**AMENDMENTS TO THE DRAWINGS**

**Jong-Joo LEE and Dong-Ho LEE**  
**MULTI-CHIP BALL GRID ARRAY PACKAGE**  
**Attorney Docket No. 9903-080/Application No. 10/828,792**

Annotated Sheet Showing Changes

FIG. 2

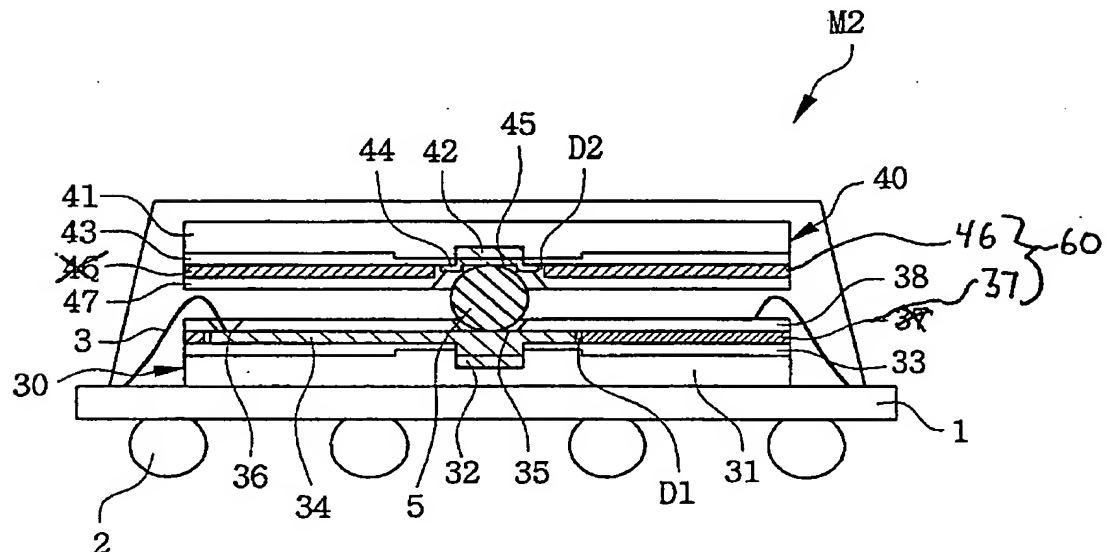
FIG. 2 is amended to include reference number 60 identifying the capacitor provided by the first and second electrode plates 37 and 46. An annotated sheet showing changes and replacement sheet are included in the Appendix following page 11 of this paper.

In a telephonic interview between the Applicant and the Examiner, conducted on August 31, 2005, the Examiner clarified that rejection was due to the capacitor not being specifically identified within any of the drawings. In response to the Applicant's question on how to overcome this rejection, the Examiner agreed that a separate reference number could be added to FIG. 2 to identify the capacitor formed by electrodes 37 and 46. FIG. 2 is amended to identify the capacitor as reference number 60 and a replacement sheet with the amended figure is included and can be found in the Appendix following page 11.
